PRRWF20250002

**WESLEY HOMES BRADLEY
PARK - PHASE 2
707 39TH AVENUE SE
PUYALLUP, WA 98374**

**LAND USE &
MX-DRO REVIEW
SUBMITTAL #3
2/16/24**

ARCHITECTURAL SITE
PLAN

1 SITE PLAN - ARCHITECTURAL

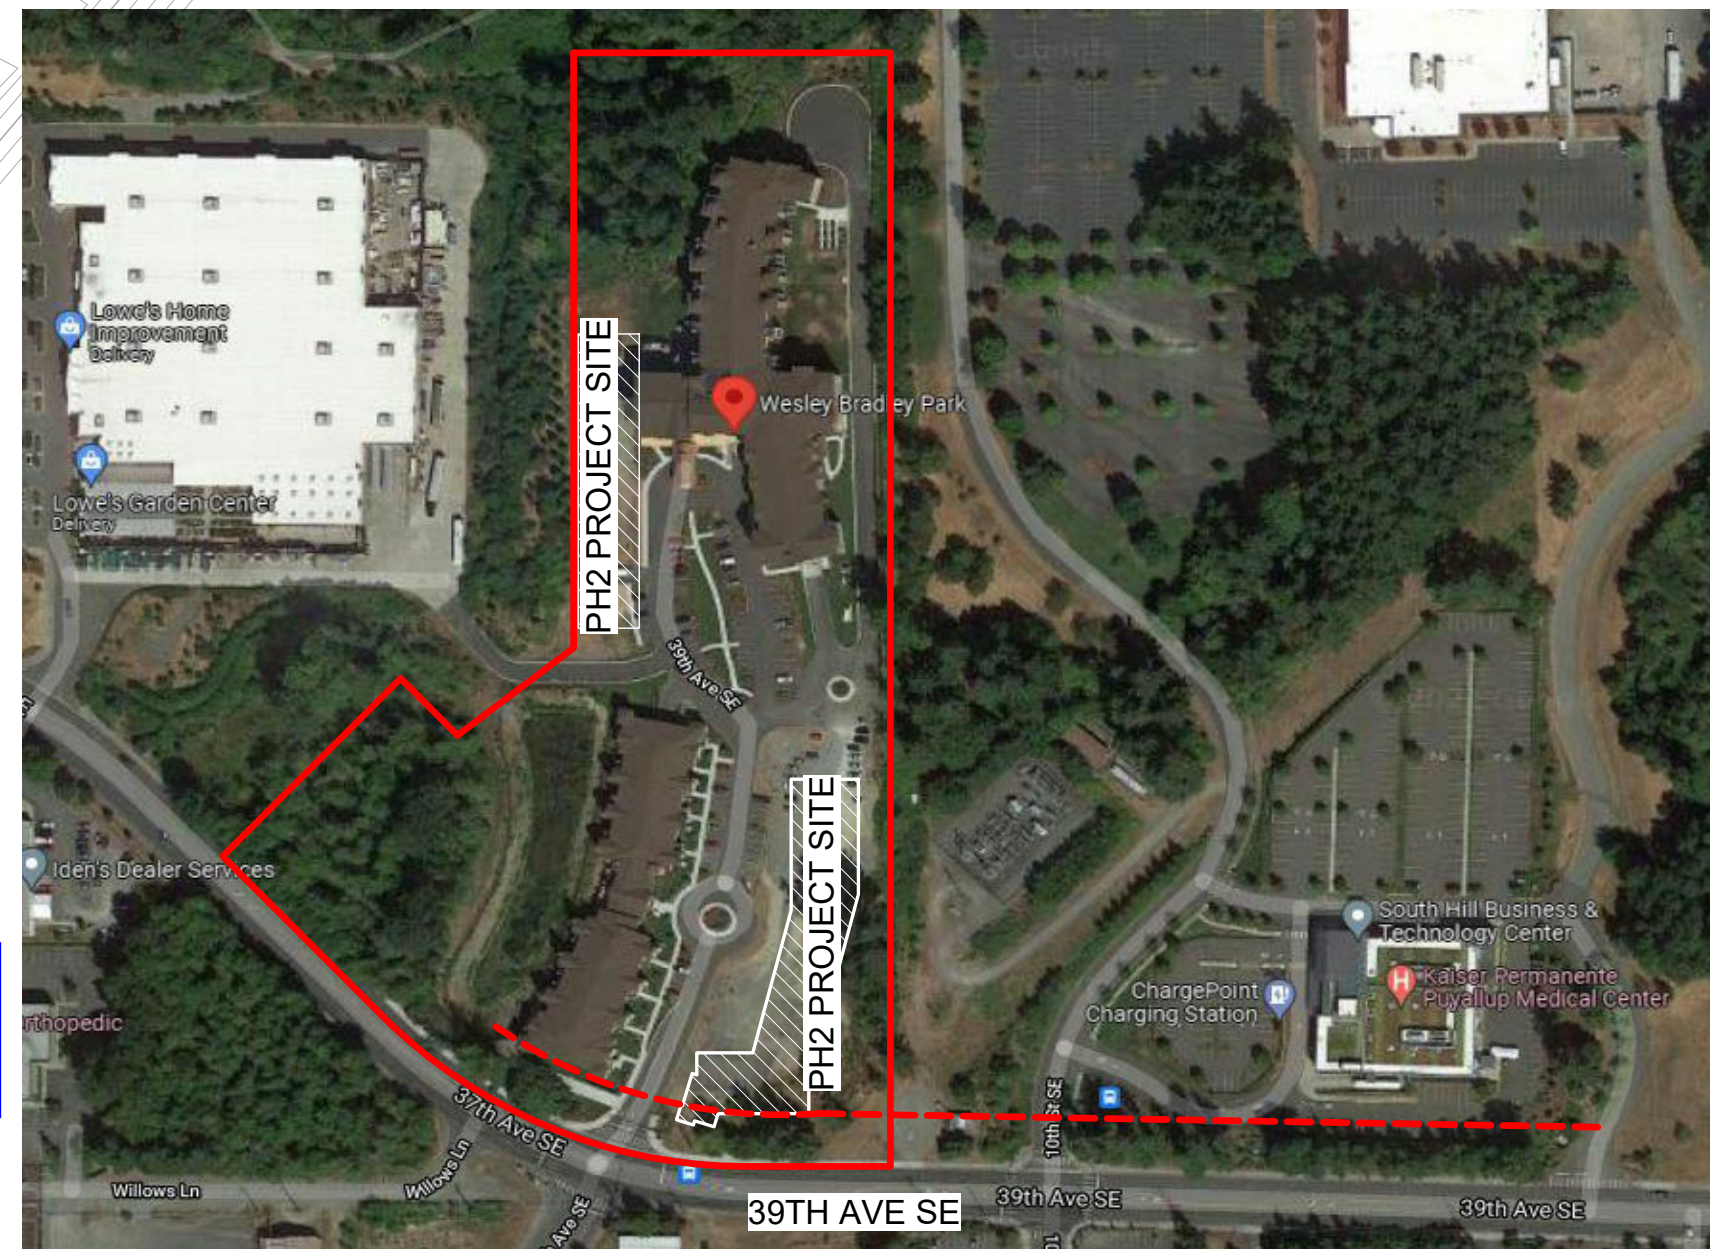
The retaining wall building permit site plan must match the approved civil site plan. Since there was a significant change to the building footprint that impacts storm drainage, utility crossings, and other civil components, a formal Plan Change Request (PCR) is required for civil construction permit PRCCP20231028. Please email the new civil plans and PCR form to the City's development engineer assigned to the civil permit.

The Engineering review on the retaining wall building permit cannot be approved until the civil permit PCR is approved first since the two permits must match. It is the applicant's responsibility to coordinate the next building permit submission with the approval of the PCR to avoid redundant reviews and permit fees. [SITE PLAN, sheet A0.1]
